UNITED STATES PATENT AND TRADEMARK OFFICE

APPLICATION NO.	FILING DATE	FIRST NAMED INVENTOR	ATTORNEY DOCKET NO.	CONFIRMATION NO.
10/722,938	11/26/2003	Lars Severinsson	03370-P0061A	9635
24126	7590	08/15/2005	EXAMINER	
ST. ONGE STEWARD JOHNSTON & REENS, LLC 986 BEDFORD STREET STAMFORD, CT 06905-5619			WILLIAMS, THOMAS J	
		ART UNIT		PAPER NUMBER
		3683

Office Action Summary	Application No.	Applicant(s)
	10/722,938	SEVERINSSON, LARS
	Examiner	Art Unit
	Thomas J. Williams	3683

Replacement Sheet
Appn. No. 10/722,938
A Device in a Vehicle Brake Arrangement
Lars Severinsson
SSJR File 3370-P0061A

Fig. 3

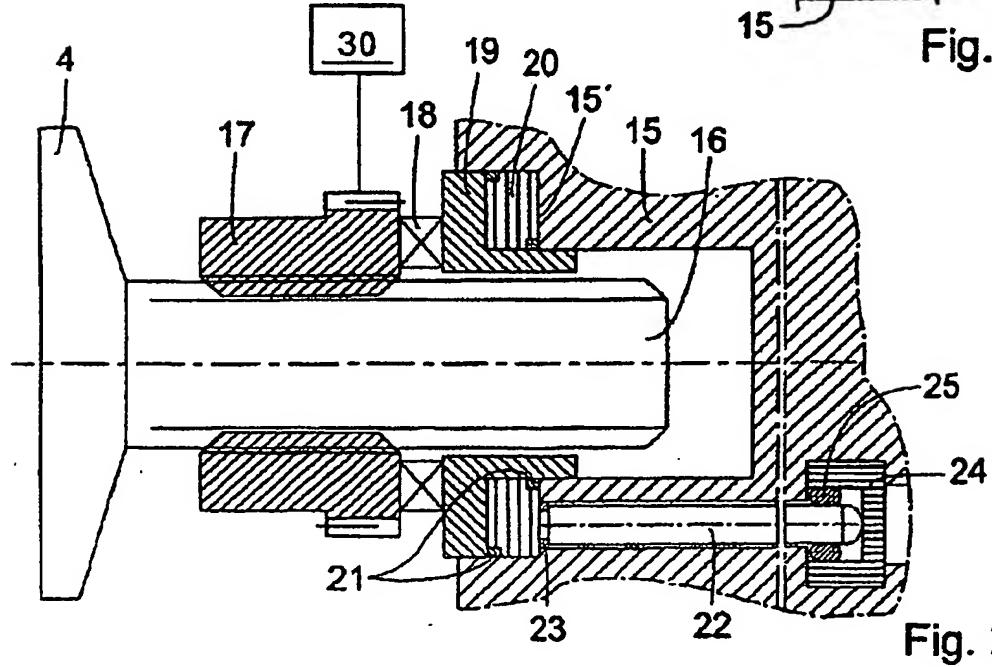
Re-claims 1-3, Rinsma et al. teach a device in a vehicle brake arrangement for determining an applied brake force, comprising: an electric motor 8, a thrust gear 22 is driven by the motor, a thrust rod 24 applies a brake force when the gear is driven, an enclosed elastically deformable medium 52 (figure 3), a reaction force from the brake force acts upon the medium, a force sensor 50 transmits signals to the motor causing the motor to stop when a desired force has been attained. Rinsma et al. teach that the force sensor can take the form of a piezoelectric sensor. However Rinsma et al. are silent regarding the structure of the piezoelectric sensor, specifically whether the sensor includes a push rod disposed between the sensor element and the deformable medium.
